ADDENDUM NUMBER 2

R18-01 Island Savings Centre Lobby Washroom Upgrades

January 19, 2018

ARCHITECTUAL ADDENDUM No.2

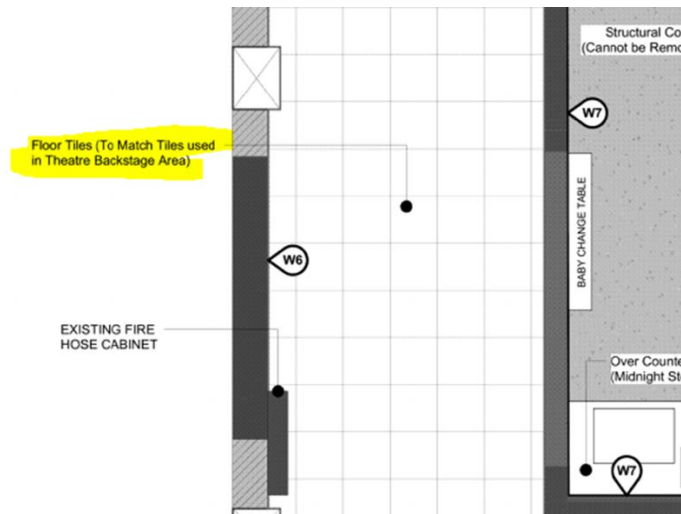
Q12. Is the Water Fountain New, or relocated? Floor Plan (A-3) says new, but Elevation (A-4) says relocated.

A12. The current water fountain is to be relocated. Noted in Architectural Addendum no 2.

- SITE ACCESS
- TEMPORARY FACILITIES
- HOARDING - PHASE 1

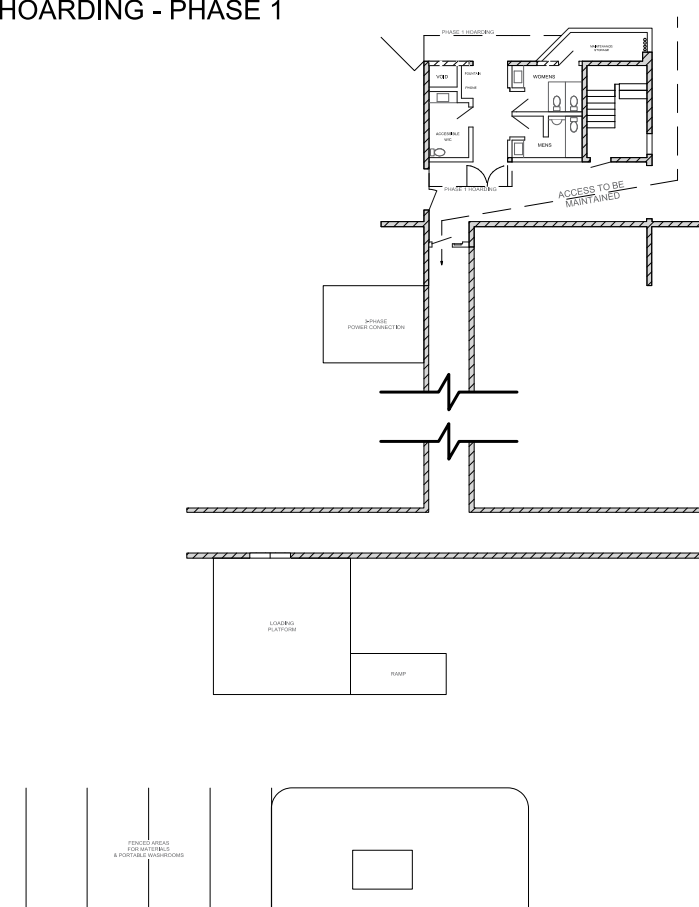
See attached Drawing for acceptable Traffic Flow

See attached Drawing for acceptable Hoarding Layout

3. Corner Guards

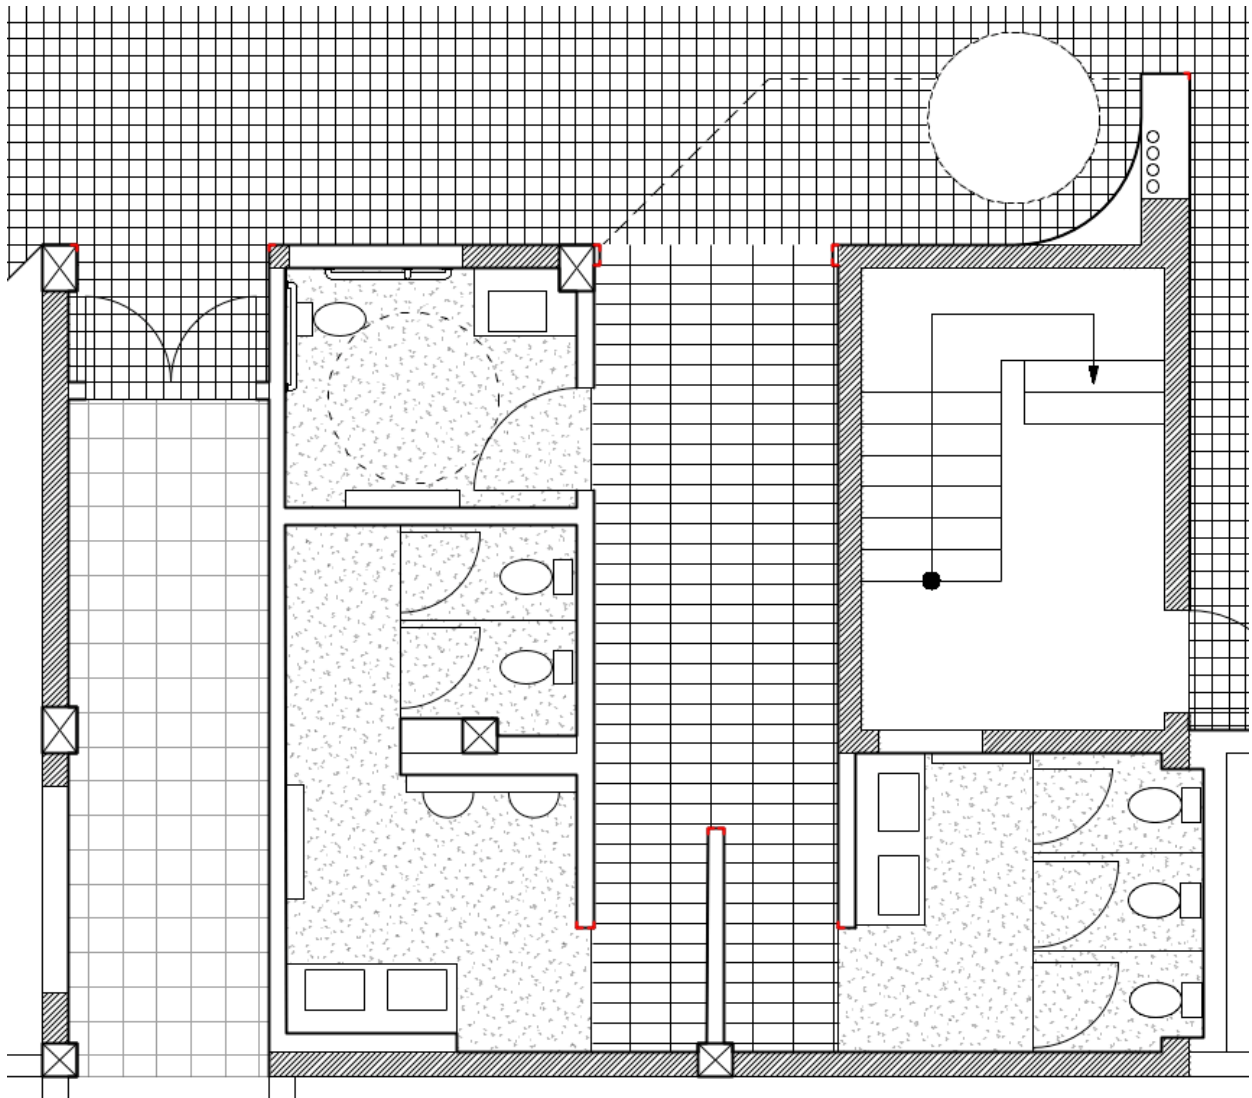
Q15. I see that wall protection and corner guards are specified, but I don't see at which locations you wish to have them provided for. Without this information, we can't include for them on this competition. If you have a drawing with these marked on them, please provide to all bidders?

Corner Guard Locations were not shown on original drawings. Please see the drawing below for locations (in red). There are 12 corners in total.

E-1

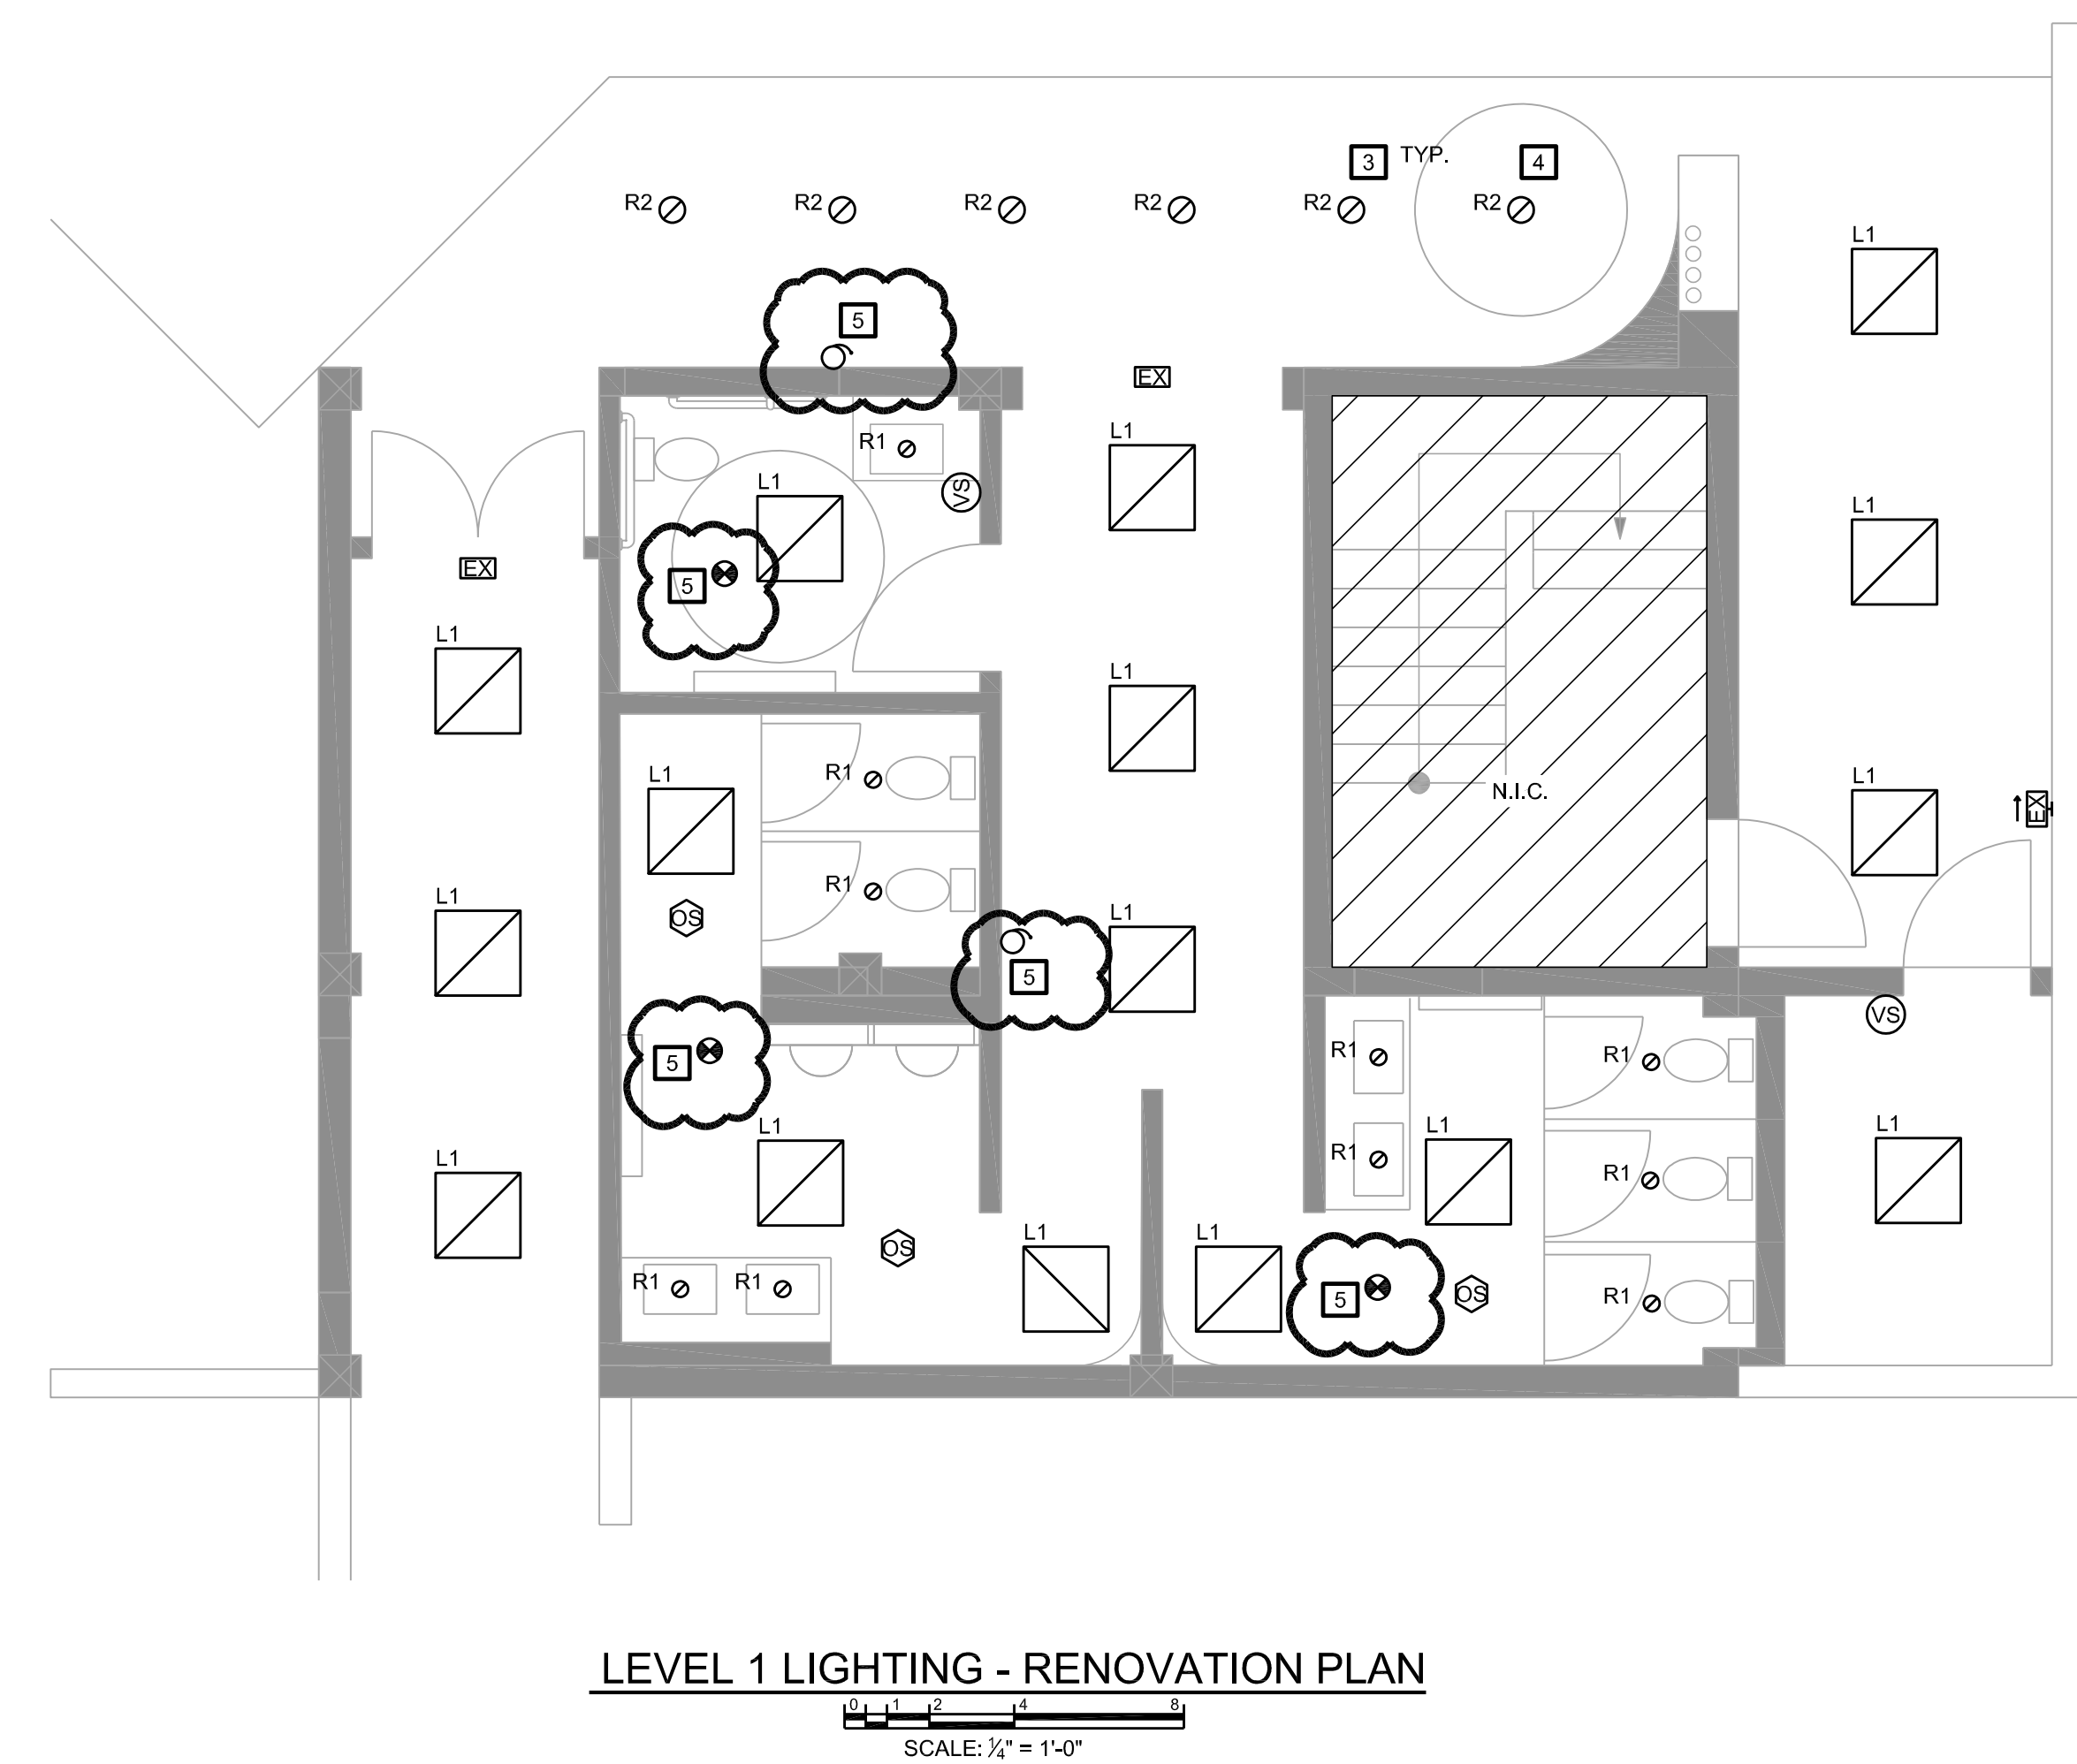
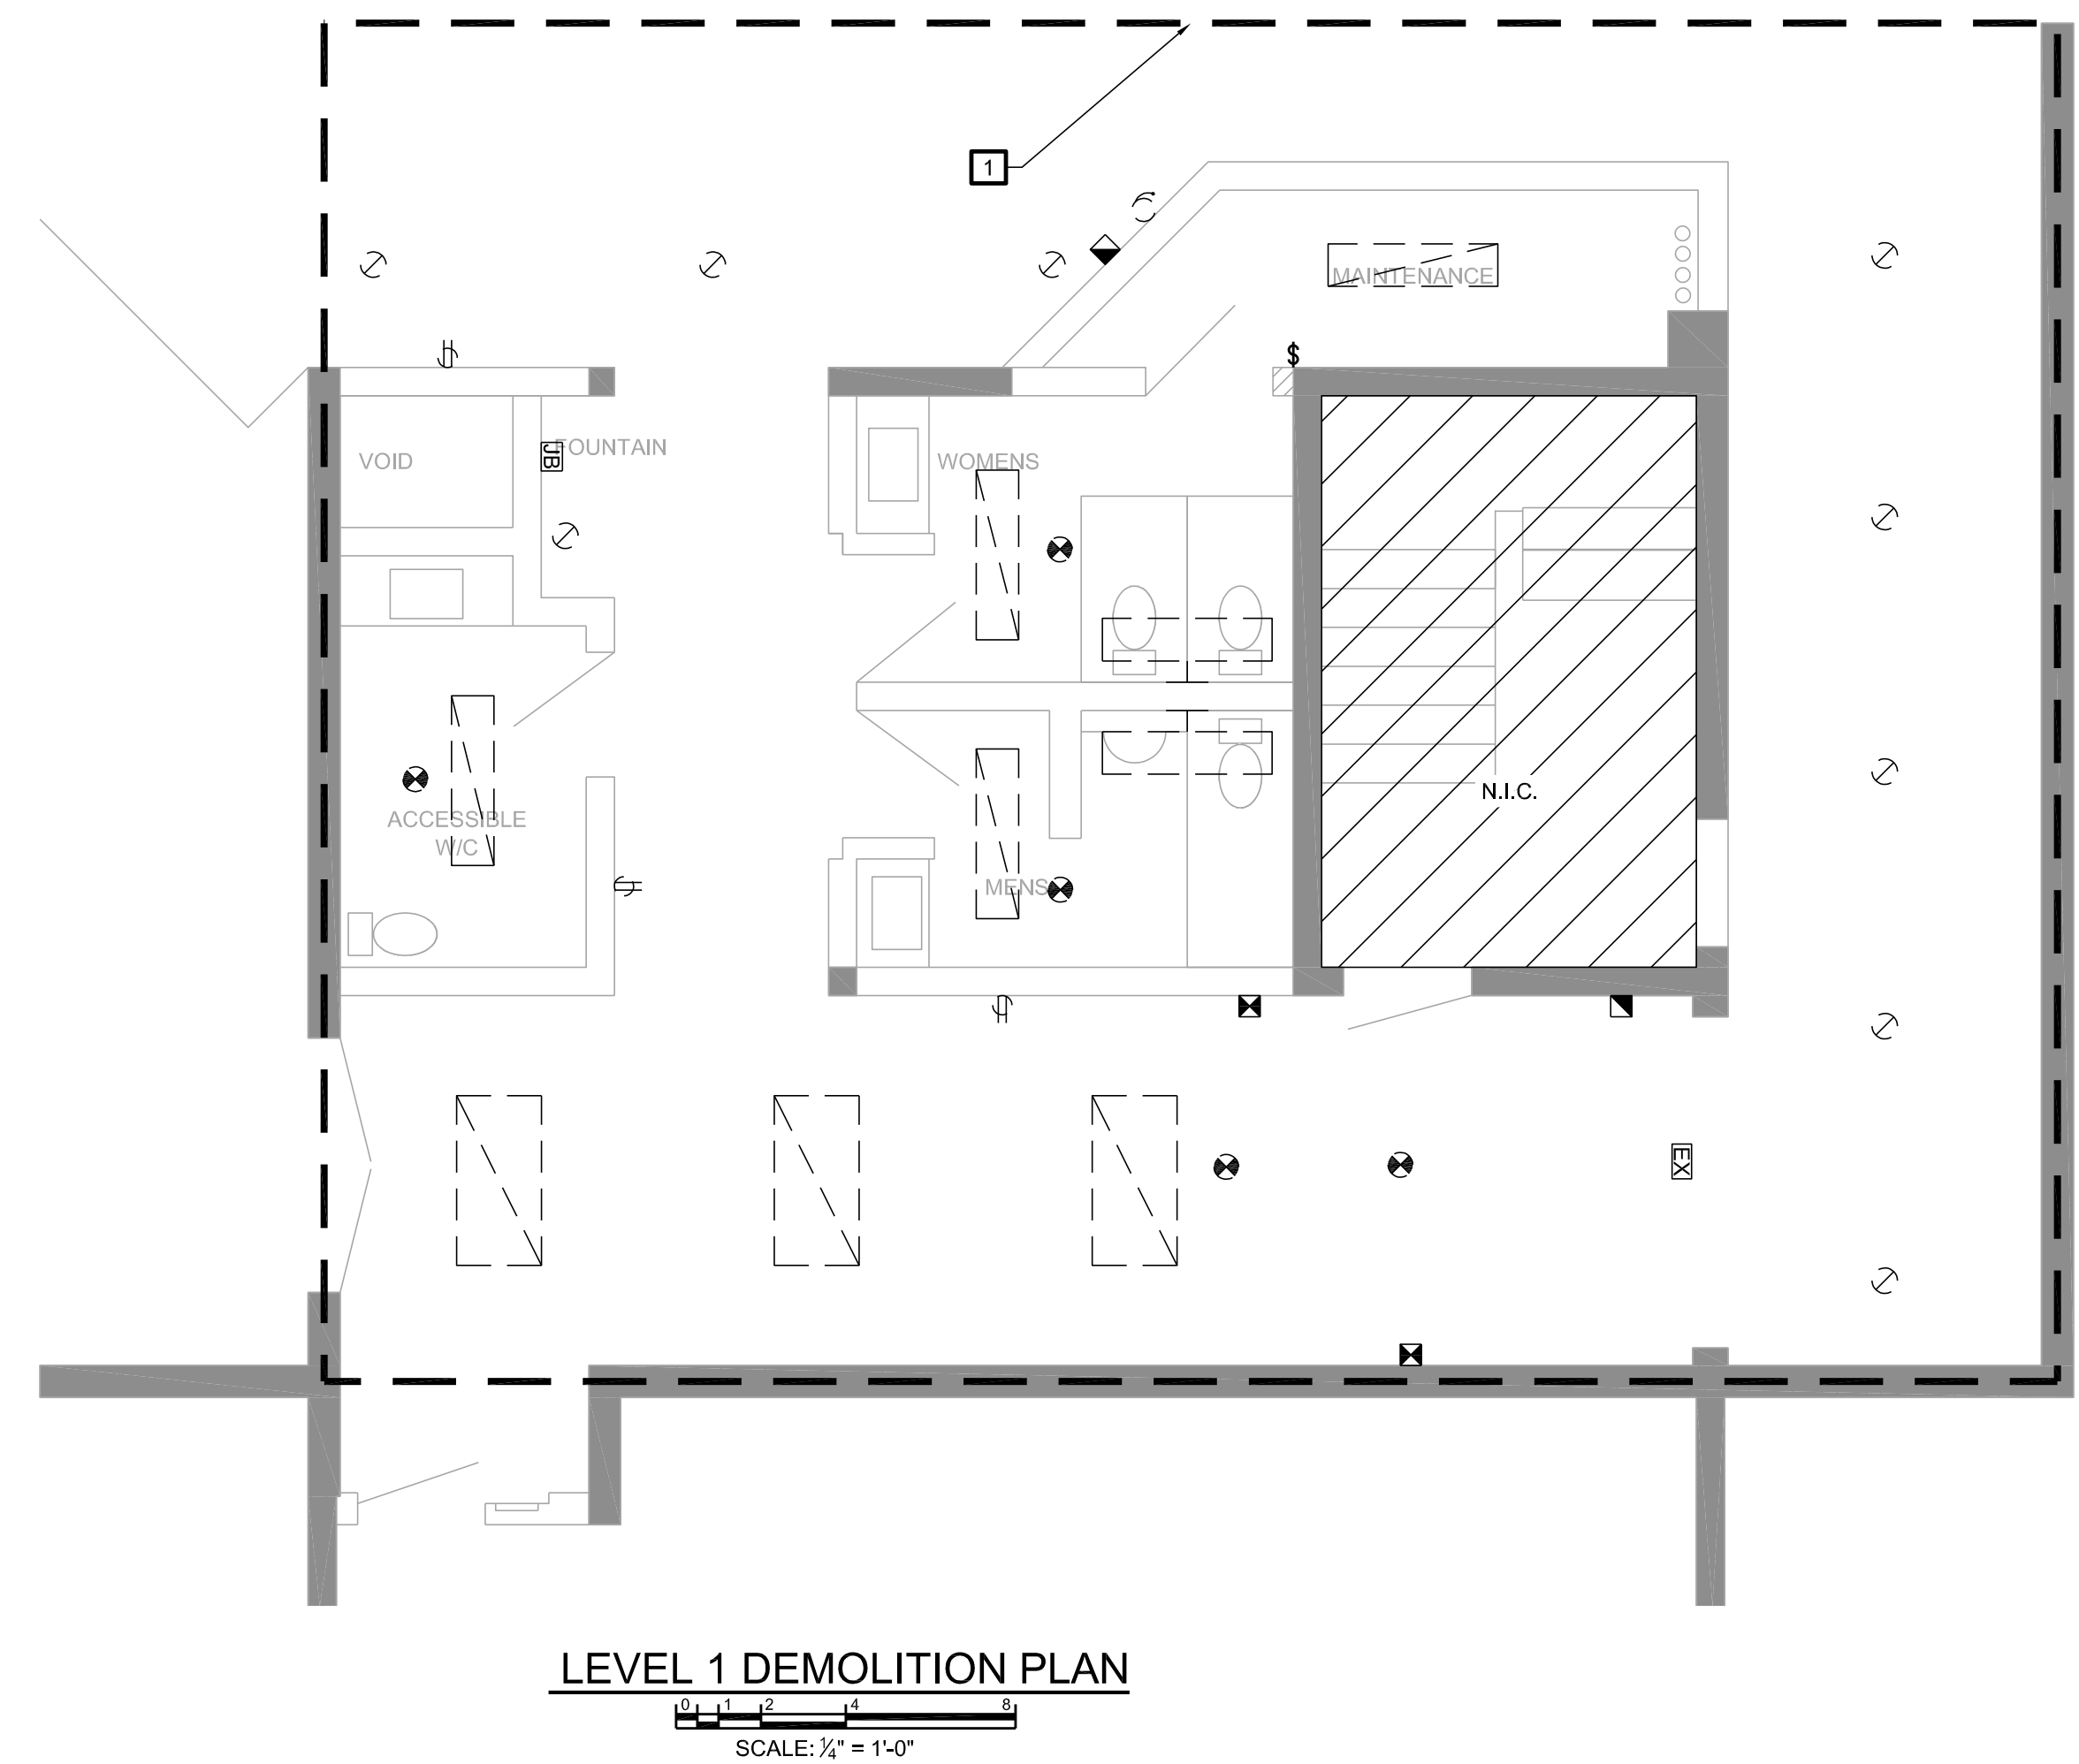
Q5. In regard to updating the fire alarm, I have a few concerns that need clarification. On drawings E0 or E1 there is nothing on either legend that identifies any fire alarm symbols that are or should be in the drawings. I have reviewed the drawings repeatedly and can't seem to find anything. Please advise.

1.1 RELOCATE and reuse existing fire alarm devices wherever possible. See attached drawing E-1

RELOCATE EXISTING FIRE ALARM DEVICES WHERE POSSIBLE
